HUMAN FACTORS ASSESSMENT: M9 ARMORED COMBAT EARTHMOVER (ACE)

REPORT DOCUMENTATION PAGE		READ INSTRUCTIONS BEFORE COMPLETING FORM																
1. REPORT NUMBER ARI Research Note 88-12	2. GOVT ACCESSION NO.	3. RECIPIENT'S CATALOG NUMBER																
4. TITLE (and Subtitle) Human Factors Assessment: M9 Armored Combat Earthmover (ACE)		5. TYPE OF REPORT & PERIOD COVERED Final Report February 1983 - December 1985																
7. AUTHOR(s) Gregory S. Krohn		6. PERFORMING ORG. REPORT NUMBER																
9. PERFORMING ORGANIZATION NAME AND ADDRESS Essex Corporation 333 North Fairfax Street Alexandria, VA 22314		8. CONTRACT OR GRANT NUMBER(s) MDA 903-83-C-0033																
11. CONTROLLING OFFICE NAME AND ADDRESS U.S. Army Research Institute for the Behavioral and Social Sciences, 5001 Eisenhower Avenue, Alexandria, VA 22333-5600		10. PROGRAM ELEMENT, PROJECT, TASK AREA & WORK UNIT NUMBERS 2Q263739A793																
14. MONITORING AGENCY NAME & ADDRESS (if different from Controlling Office) - -		12. REPORT DATE April 1988																
		13. NUMBER OF PAGES 185																
		15. SECURITY CLASS. (of this report) Unclassified																
		15a. DECLASSIFICATION/DOWN

Figure 52. The location of the battery box below the radio box and behind the radiator grille.

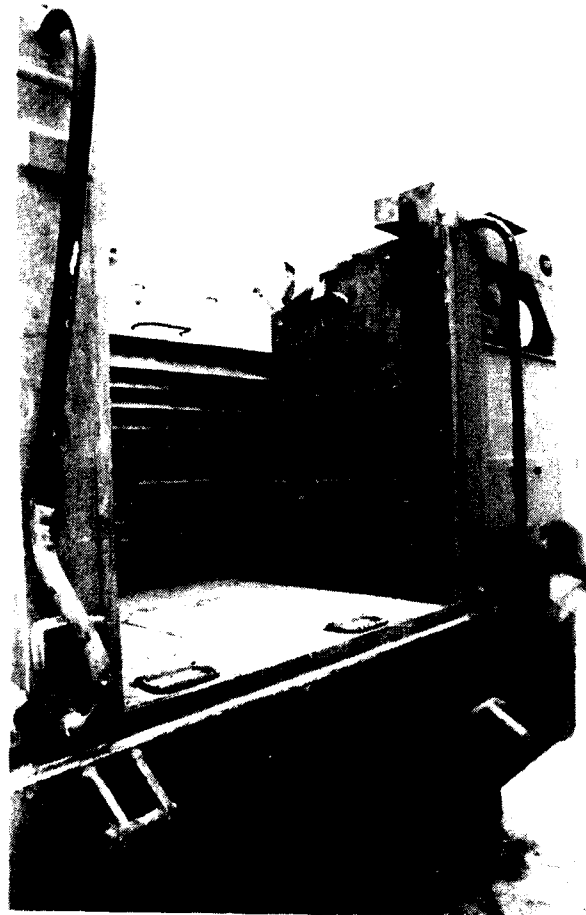
Description of the Deficiency: Figure 52 shows the battery box located beneath the radio box at the rear of the M9. Three operators and four mechanics reported that they could not see into the furthest battery ports or inspect the terminals because their view and reach were blocked by the radio box. The radio box is approximately 12 in (29 cm) above the batteries. The limited space also makes removing and replacing the batteries difficult.

Implications for the Mechanic, the Operator, and the Equipment: The battery fluid was frequently low due to the high temperatures created by the muffler and the radiator. The low fluid levels were often not detected during daily PMCS maintenance checks. Damage to the batteries may result.

Potential Solutions: The radio and batteries may need to be relocated. High temperatures generated by the muffler and radiator damaged the equipment during the test. If the hatch and driver's station are reconfigured, the radio might be placed in the driver's station and the battery box might be located above the fuel tank.

Figure 53. A mechanic reaching between the roadwheels to position the dog bone jack.

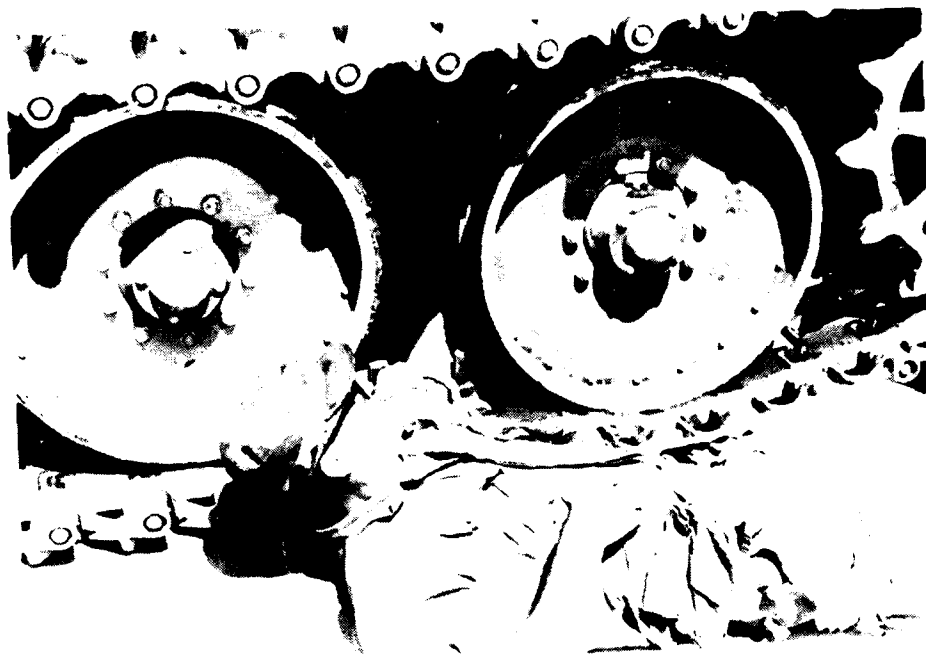
Description of the Safety Hazard: Figure 53 shows a mechanic reaching into the roadwheels in order to hold a dog bone jack in place between the upper and lower portions of the track. Figure 54 shows the dog bone jack.

1. Use the hydraulic jack only on hard paved surfaces.
2. Modify the dog bone jack to make it self-standing during positioning of the vehicle. This might be done by adding a hinged bipod to one side of the jack. The bipod would angle outward from the jack and wedge into the ground, creating a tripod of the jack.
